PREPARED FOR THE URBAN DESIGN COMMISSION

Project Address: 341 State, 315-319 W. Gorham, 321 W. Gorham, and 322 W. Johnson Streets

Application Type: Advisory Recommendation on Proposed Planned Development (PD) Zoned Development, New Mixed-Use Building for Student Housing, Retail and Incubator Space
Final Approval is Requested

Legistar File ID # [63798](#)

ATTACHMENT 1 DOWNTOWN ZONING HEIGHT MAP- With Subject Site Highlighted (Orange)

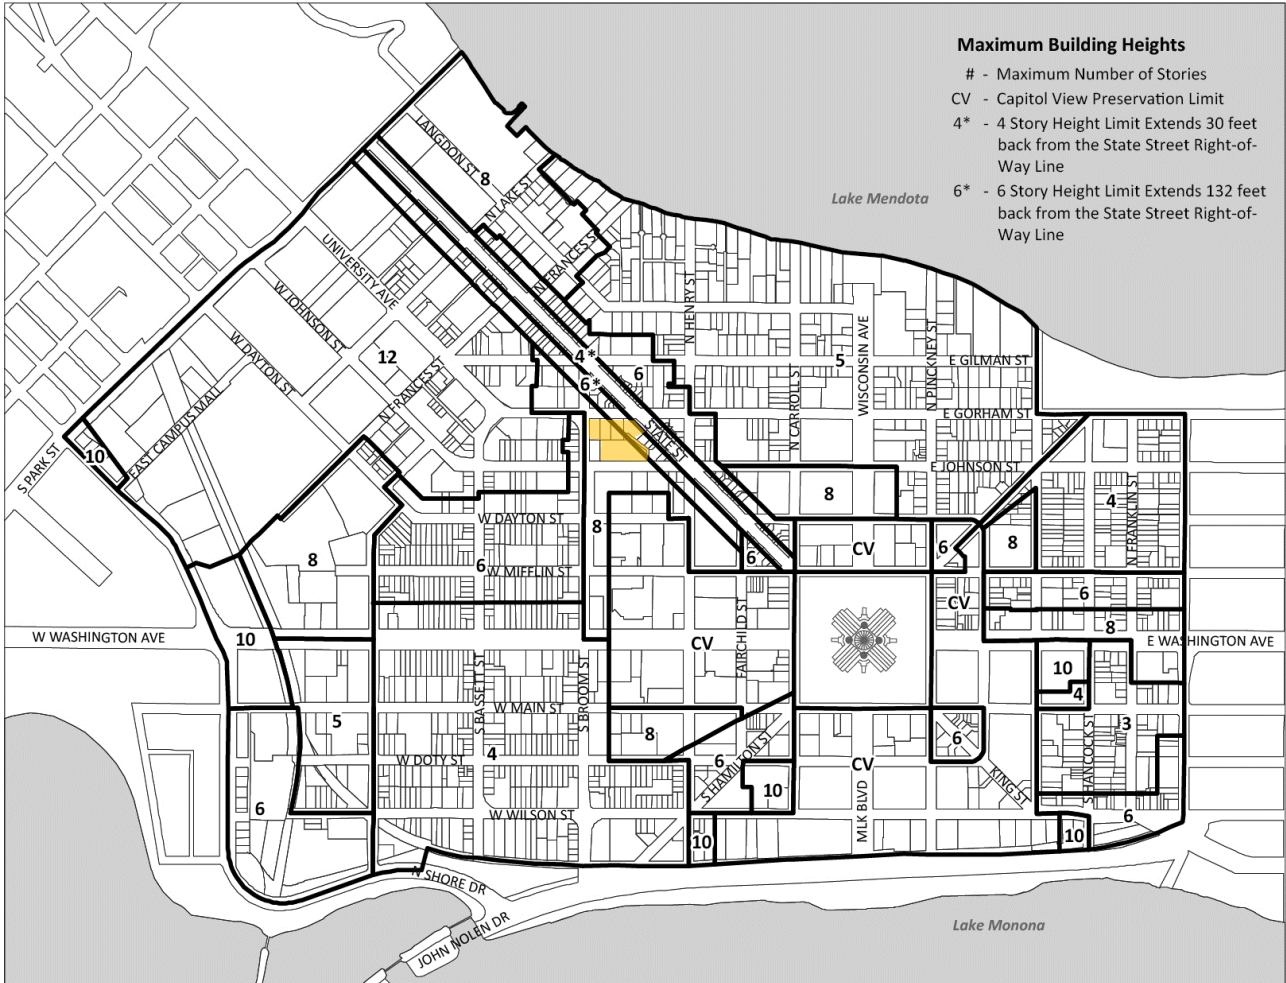
The [Downtown Height Map](#) (Section 28.071(2)(a) of the Zoning Code) requires a four (4)-story height limit for the portion of the site which extends 30 feet back from the State Street Right of Way (ROW). Moving further away from State Street, to the south, the height limit increases to six (6) stories for the portion of the site located from 30 to 132 feet from the ROW. The balance of this site has a mapped height maximum of eight (8) stories. The submitted plans appear to comply with the four and six-story heights, though portions of the area with an eight-story limit are proposed for 10 stories. A copy of the height map is included as an appendix to this report.
